CRITICAL SERVICE BULLETIN

CSB94-15

SUBJECT: CRANKCASE STUD INSPECTION

FIGURE 1 .250 - 28 STUD LOCATIONS

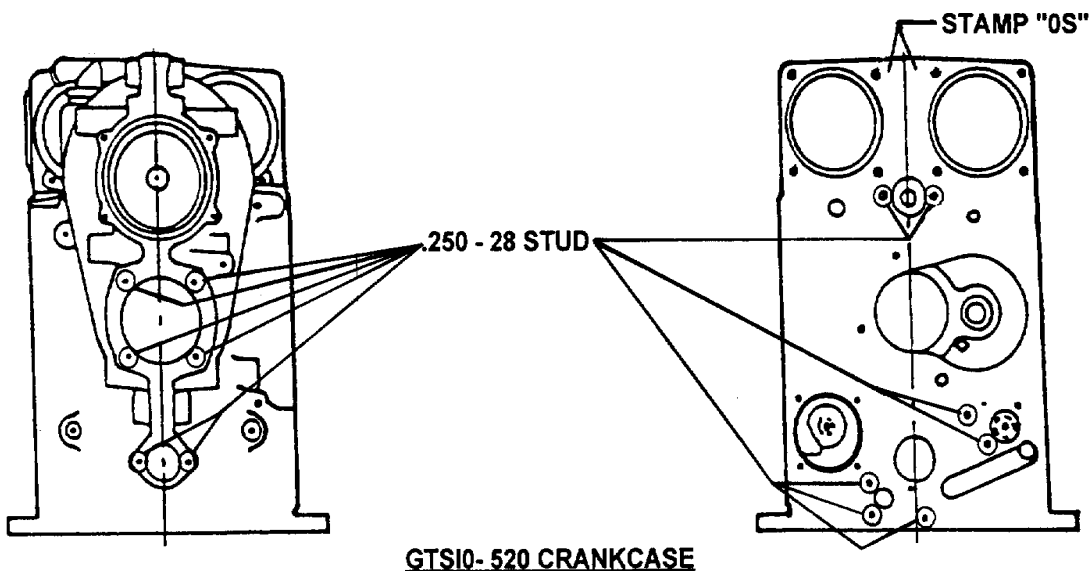
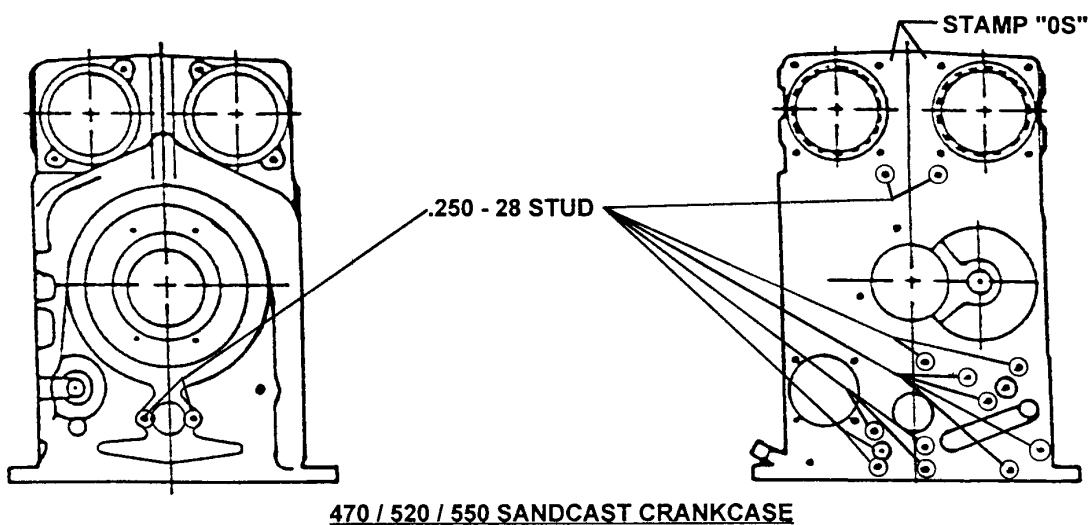
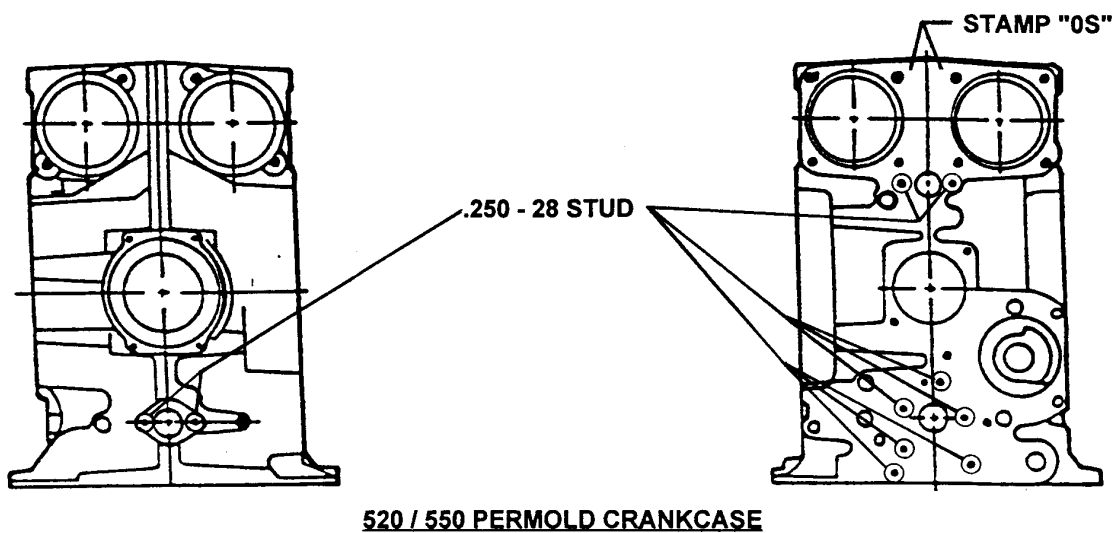
1. Open or remove the cowling necessary to gain access to the rear of the engine.
2. Remove the two sets of nuts and washers from the idler gear support pin studs. These studs are positioned on the rear (accessory section) of the crankcase, just below the left and right accessory drives. See Figure 1. DO NOT remove the idler gear support pin.

8. Measure all of the .250" stud extension heights and record their locations. See Figure 1. This is necessary for proper installation of the replacement studs. Remove all .250"-28 studs from the front and rear of the crankcase using an appropriate stud removal tool and record their lengths as they are removed so that the same length stud is installed in the same location. Discard the old studs.

9. Add a small amount of clean grease to the 1/4-20 GH7 tap (supplied in the stud kit) to prevent aluminum material generated during tapping from entering the engine. Run the 1/4-20 GH7 tap into and then out of each .250" stud hole location (except the idler gear pin stud holes) indicated in Figure 1. Thoroughly clean grease and debris from the stud holes by saturating a clean cloth with Loctite Primer "N" and cleaning each hole until threads are clean. Final cleaning and preparation of the threads is accomplished by spraying a light film of Loctite Primer "N" into the stud holes.

Figure 3. Use a .250"-28 stud driver and install the appropriate length studs in their proper locations, to the recorded extension heights. Allow at least 30 minutes for the Loctite to cure prior to component installation. Stamp the letters "OS" on each side of the crankcase split line using a 1/8" metal stamp. See Figure 1 for approximate location.

FIGURE 2 INSPECTING .250 - 20 TAPPED HOLES

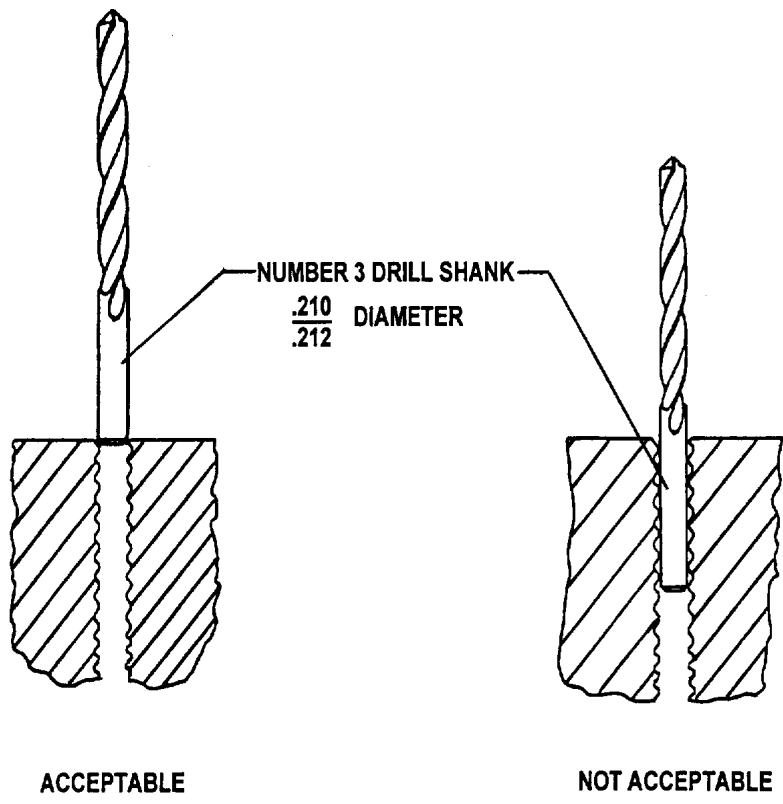
3. Measure the stud height extending out of the crankcase and record. Using a suitable stud remover or double nuts, remove the two .250" studs.
4. Check these tapped holes in the crankcase to determine if they are oversize by using a #3 (.2130) drill bit. See Figure 2. This will be accomplished by first measuring the shank of the drill bit with a calibrated micrometer. The diameter of the shank must measure .210" - .212". Insert the shank end of the drill bit into the tapped .250"-20 hole. The shank should not extend into the tapped portion of the hole. If it does not, reinstall the two studs to the recorded height using Loctite Primer "N" and 271 Stud Lock. Allow at least 30 minutes for the Loctite to cure prior to the installation of the idler gear pin attaching hardware. Torque nuts to 90 - 110 inch pounds. Make a log book entry as to compliance with this service bulletin as no further action is required. If the shank of the drill bit extends into the tapped portion of the hole, proceed as follows.

FIGURE 3 OVERSIZE STUD IDENTIFICATION

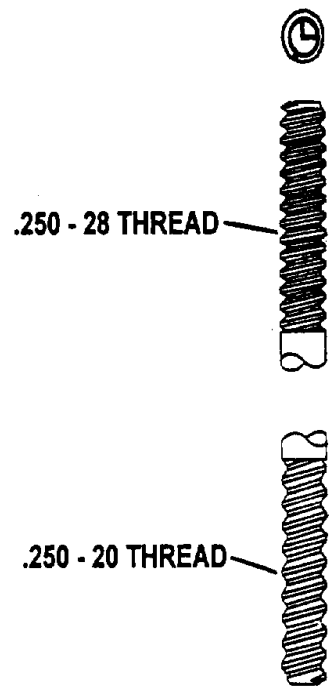
10. Using the studs contained in the appropriate kit listed in Table 1, apply a line of Loctite 271 along the .250"-20 threads of the studs. These studs are .007 oversize and are identified by being blue in color and a "L" shaped stamp on the .250"-28 end. See
